Service Bulletin S06KV

Subject: “MICO” Low Pressure Switch Shortened Service Life

Models Affected: 2006 Model Year Blue Bird All American model buses and
2006-2007 Model Year Blue Bird Vision Model Conventional Buses
Equipped With Hydraulic Brakes and Option 40051 Door Brake
Interlock

FIGURE 1
(691 models)

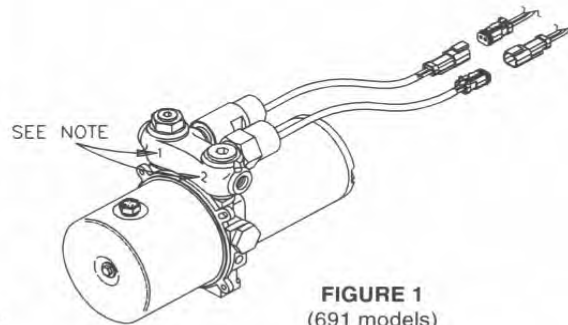
Regardless of manufacture date, the position of the high and low pressure switches have remained the same. See Figure 1, position 1 will always have a pressure switch stamped 1-800 and position 2 will always have a pressure switch stamped 2-10. Be sure to install the correct replacement switch.

1. Replace pressure switches as necessary and torque 17.6-23.1 N-m (13-17 lb-ft). **NOTE: Torque only on surface flats.**
2. **691 models:** Reattach wire connectors. See Figure 1.

FIGURE 2
(earlier 690 models)

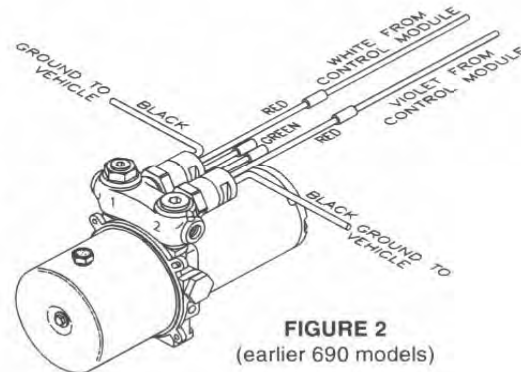
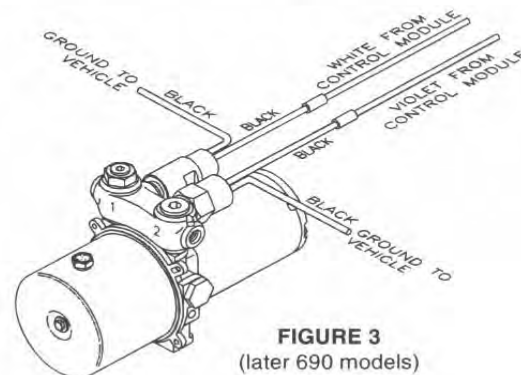
3. **690 models:** Earlier models of the 690 power unit provided a black wire, red wire, and green wire from each of the pressure switches as shown in Figure 2. These style switches are no longer available. Later models use pressure switches which provide two black wires from each as shown in Figure 3. When replacing pressure switches, either one of the black wires from each pressure switch can be used to connect to ground. Connect the other black wire from the pressure switches to the white wire or violet wire as shown in Figure 3. The pressure switch that connects to the white wire is stamped 1-800. The pressure switch that connects to the violet wire is stamped 2-10. **NOTE: Replacement switches may have connectors similar to FIGURE 1. Remove connectors as needed.**
